# Edmondson Park Sites 1-3

## Response to DEP Comments

Fig 4.8.11  
 Future provision of Lift

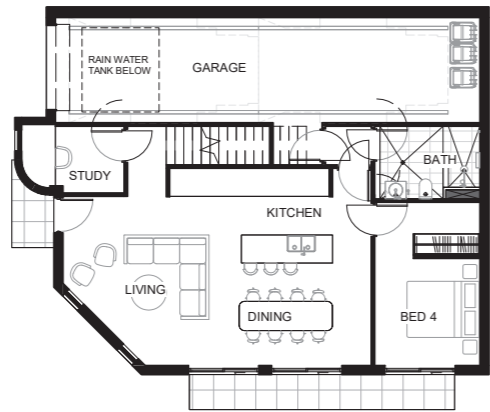
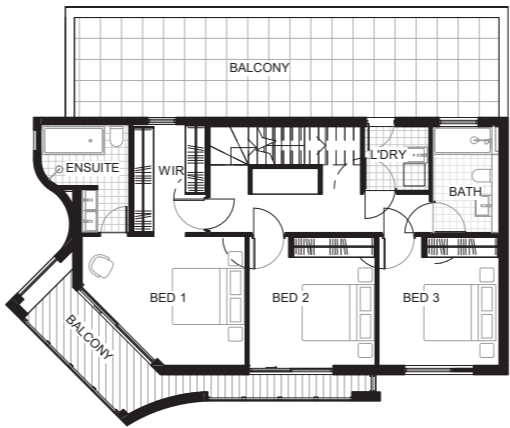
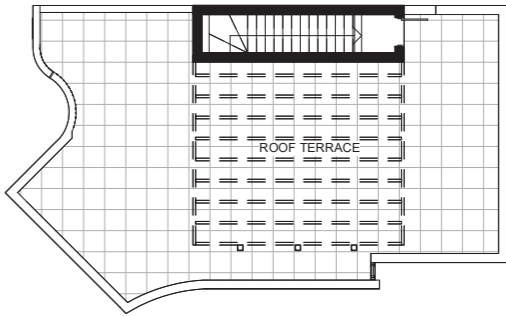
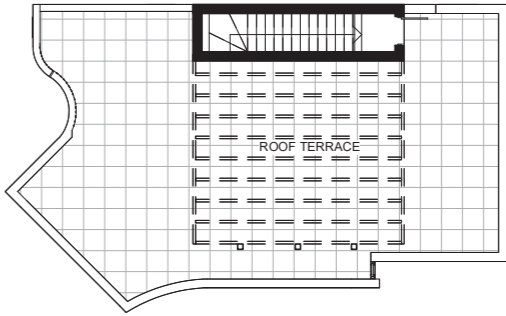
The Panel notes that there are a lot of 3-storey terrace houses which may not suit ageing people or people with restricted mobility. The Panel recommends safeguarding space for the potential inclusion of chair lifts or vertical lifts in future.

**A vertical lifting study has been conducted in response to Item 4.2 which demonstrates that the safeguarding of locations for spring lifted vertical lifting devices are able to be accommodated in particular Terrace Typologies. Vertical lifting devices are not proposed as part of this DA.**
